METROPOLITAN GOVERNMENT OF NASHVILLE AND DAVIDSON COUNTY

STAFF RECOMMENDATION
1409 Sumner Avenue
August 20, 2014

Application: New construction—detached accessory dwelling unit (DADU)
District: Eastwood Neighborhood Conservation Zoning Overlay
Council District: 06
Map and Parcel Number: 08305045100
Applicant: Van Pond, Jr.
Project Lead: Paul Hoffman, paul.hoffman@nashville.gov

PROPOSED
SITE PLAN
Issued: 29 AUGUST 2014

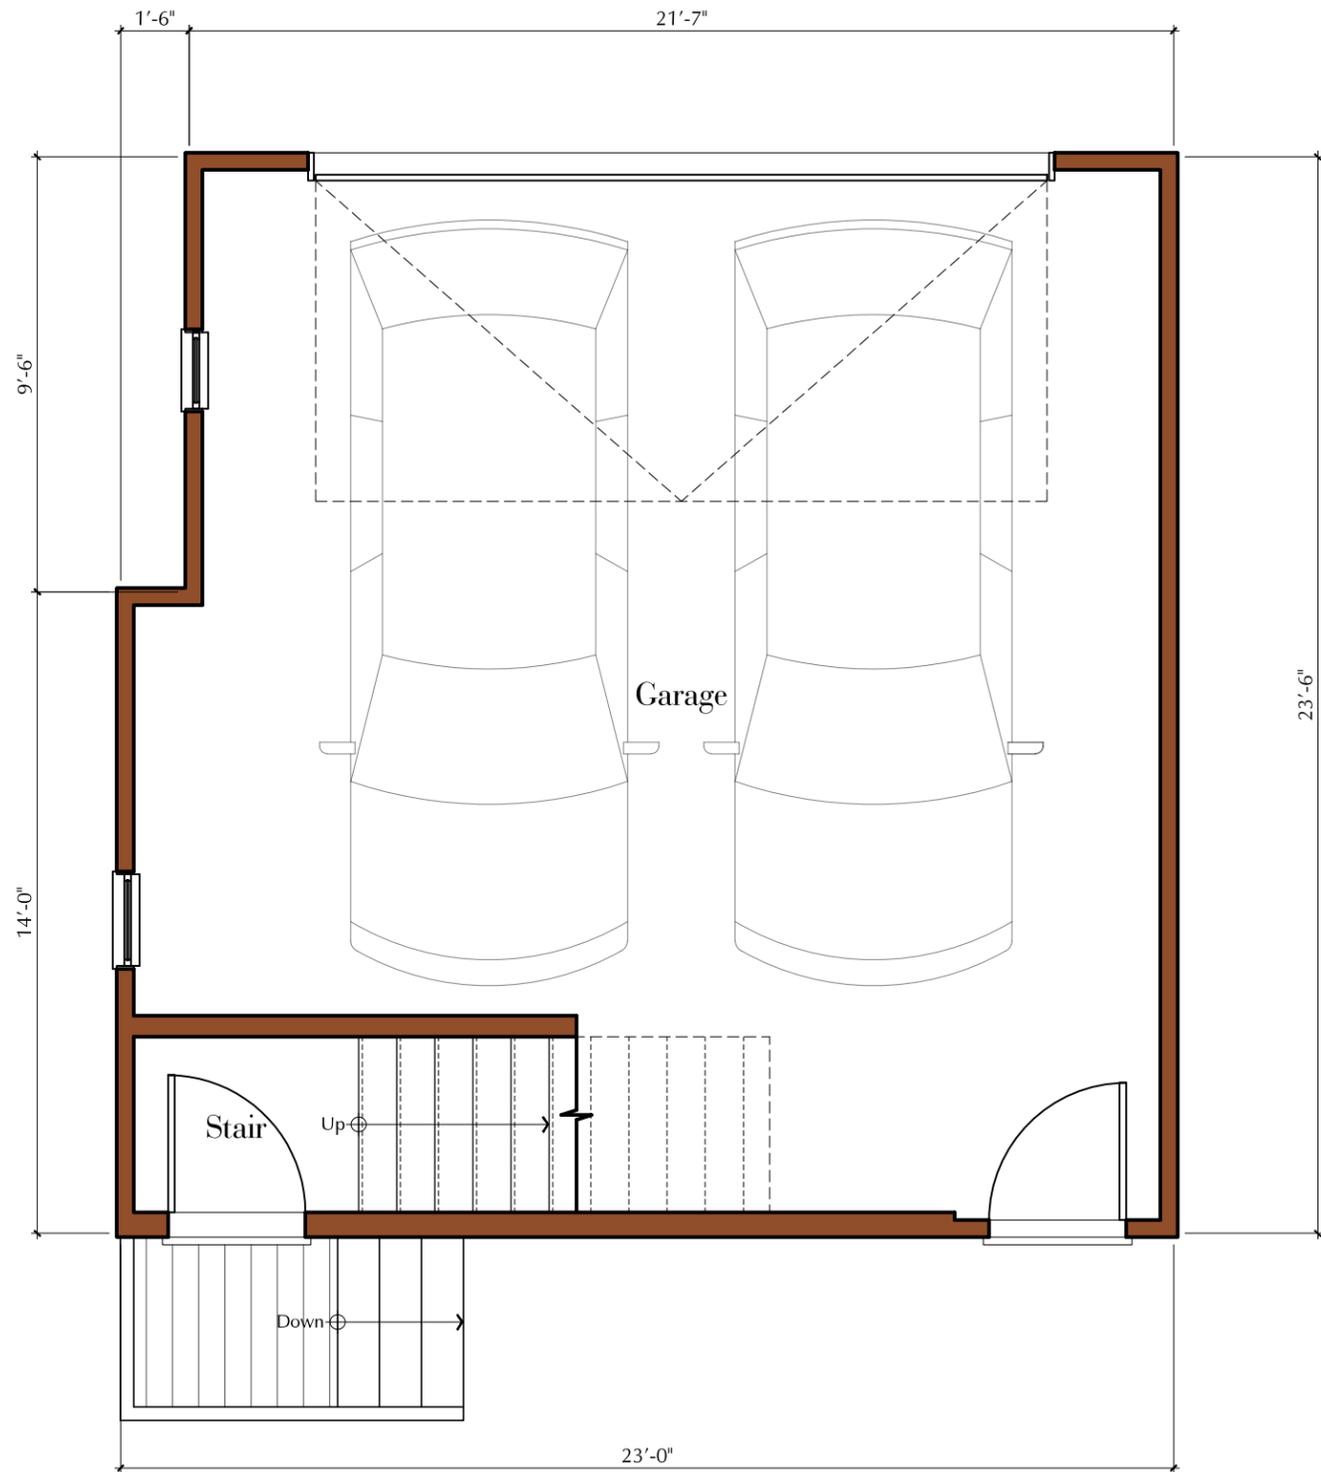
Setbacks: The proposed DADU will be three feet (3') from each side property line and approximately twenty-one feet (21') from the rear. This meets base zoning setback requirements of three feet (3') from the side property lines and ten feet (10') from the alley for the side with garage doors. The building meets Standard 4.

Site Requirements: The proposed outbuilding will be located at the rear of the lot, behind the primary building at 1409 Sumner Avenue. There will be ten feet (10') between the house and the accessory building, meeting the requirement for minimum separation. The proposal meets Standard 5 for DADUs.

Driveway Access: The detached accessory dwelling is part of a garage, and is proposed to be alley loaded. No curb cut will be added to the front of the lot. The project meets Standard 6.

PROPOSED
 PLAN

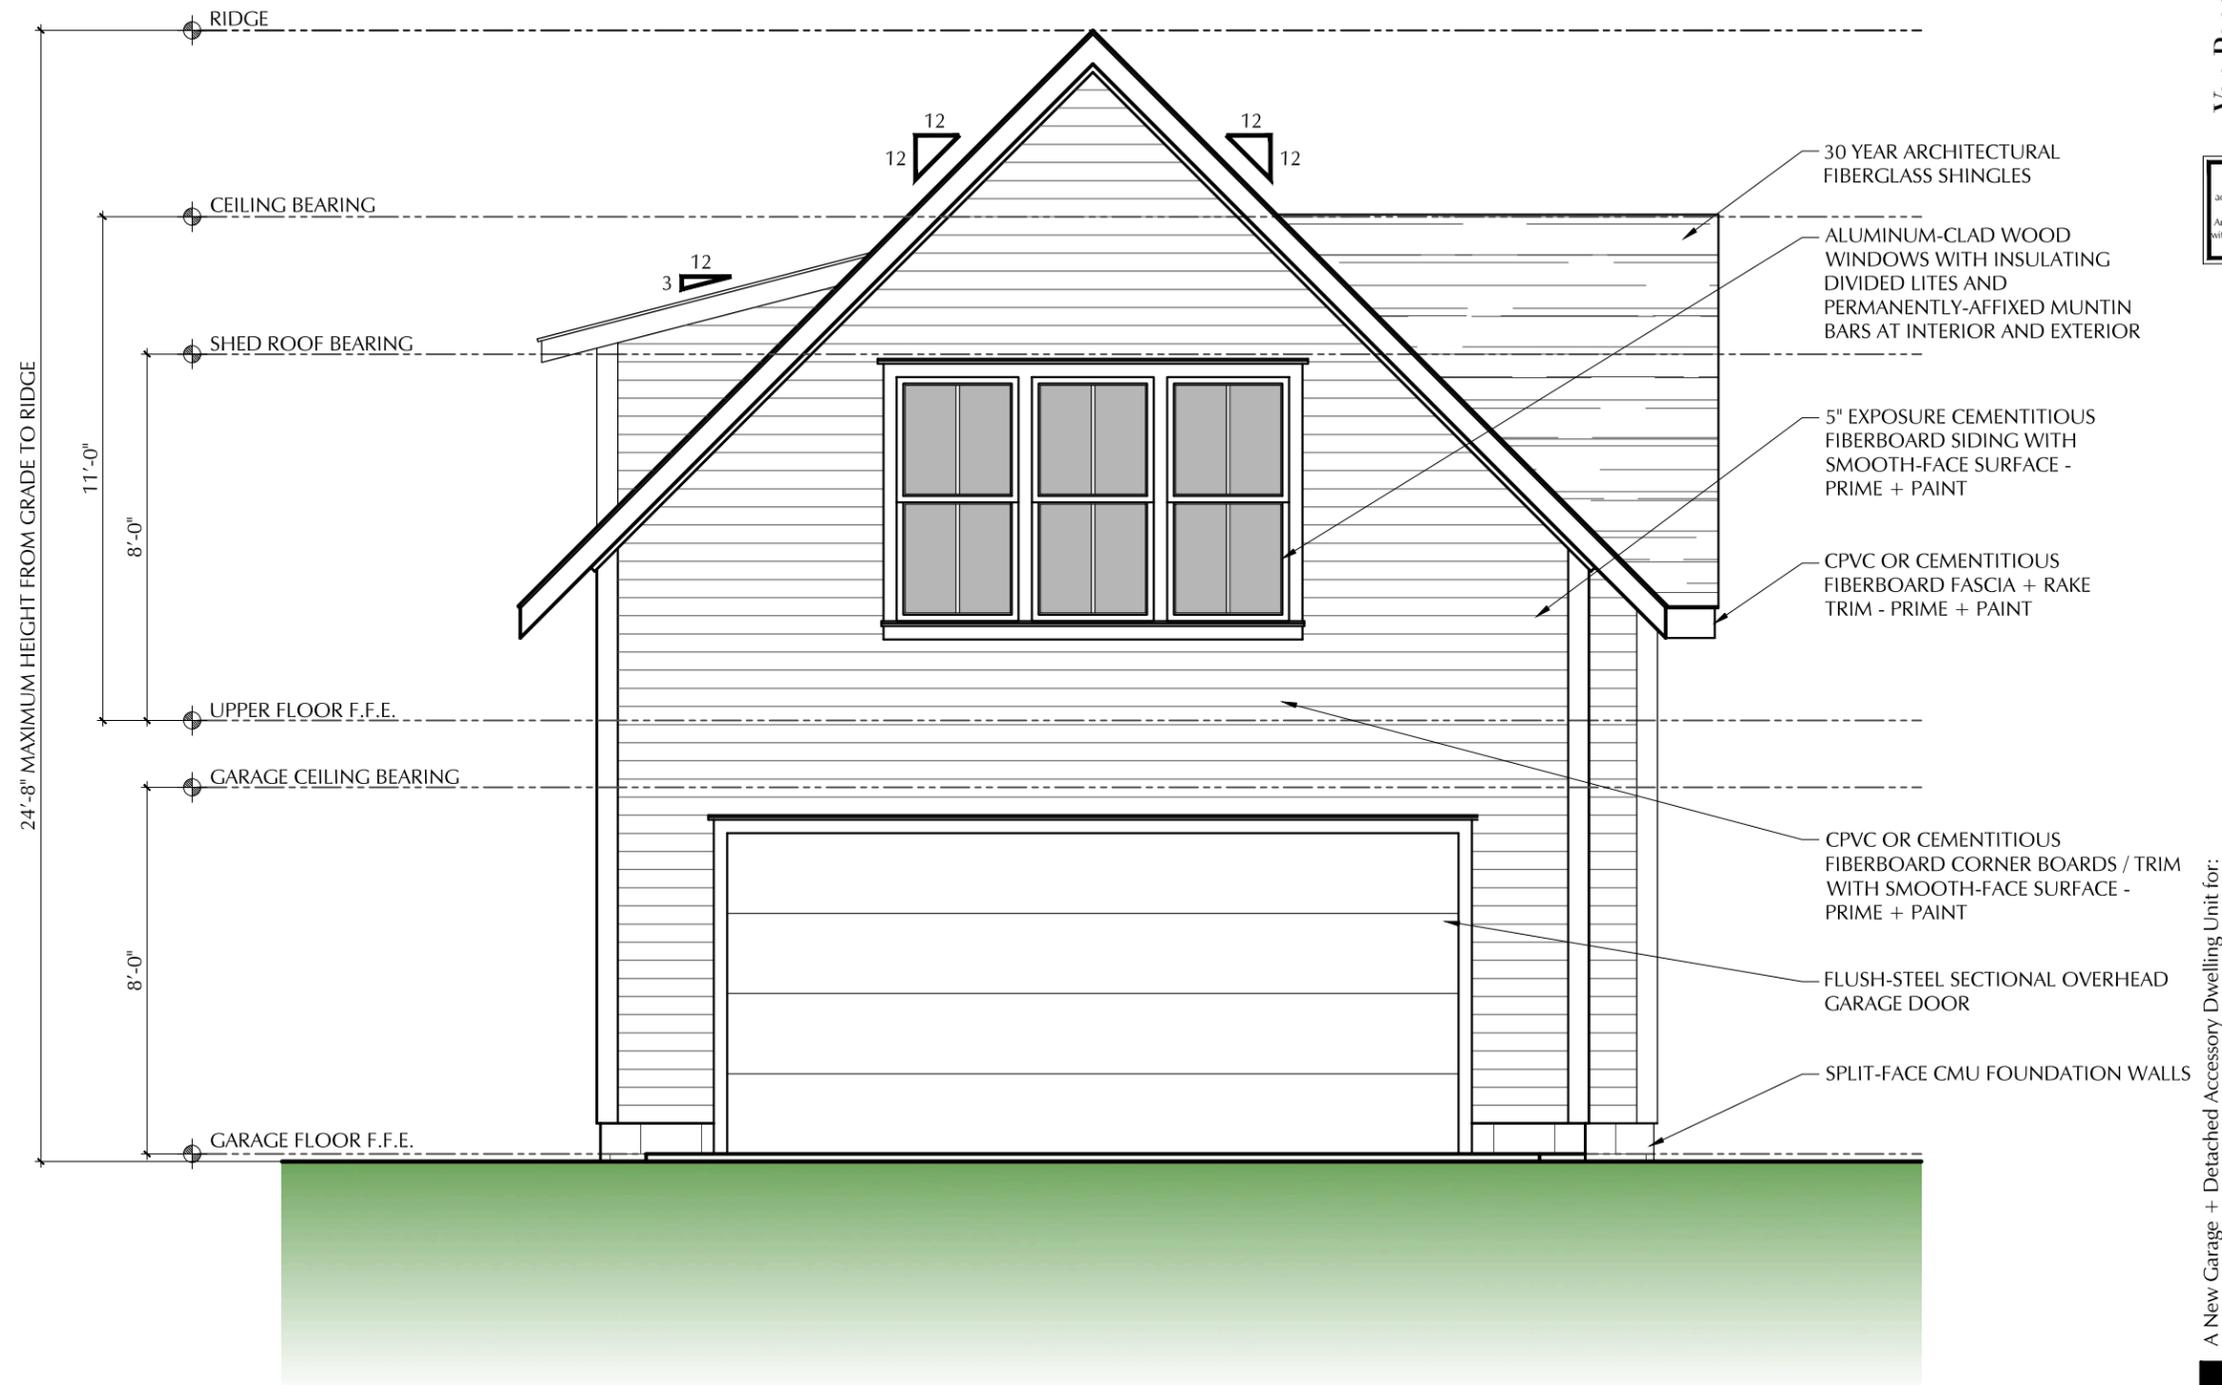
Design Standards: This design is compatible with the style of the new primary building. As drawn, the rear-facing dormer sits atop the exterior wall. The DADU Standards state "accessory dwellings may have dormers that are setback a minimum of two feet from the exterior wall." Staff therefore recommends that the shed dormer on the east elevation meet this requirement. Meeting this condition, the project will meet Standard 8 of the Standards and II.B.8 of the design guidelines.

1. The owner file a restrictive covenant for the detached accessory dwelling unit;
2. Staff approve the windows and doors and roofing color prior to purchase and installation;
3. The shed dormer be moved back at least two feet (2') from the exterior wall beneath; and,
4. The HVAC and other utilities shall be located to minimize their visibility from the street.
